**ADDENDUM NO. 2
REQUEST FOR PROPOSAL FOR THE INTERIOR RENOVATION AT O'CONNOR CHILD
CARE CENTER**

ROSTER RFT NO.: Doc3512316731

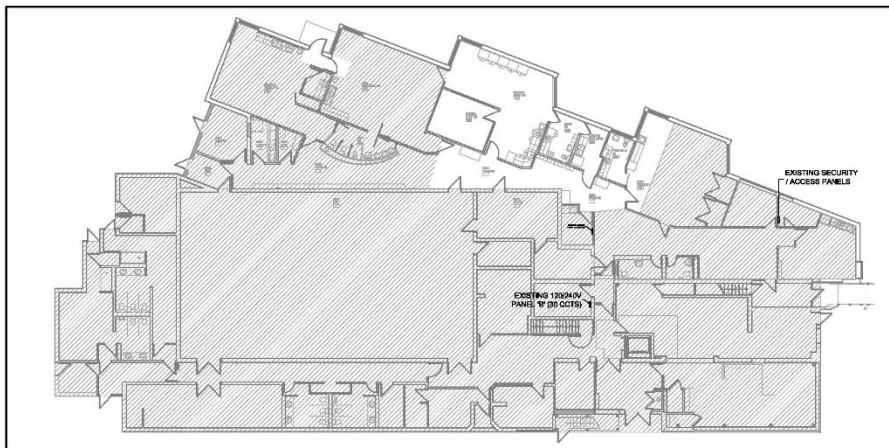
Q2 : Please provide the name of the manufacturer of Panel A.

A2 : No manufacturer name on panel 'A'. Find attached photos of panel 'A'.
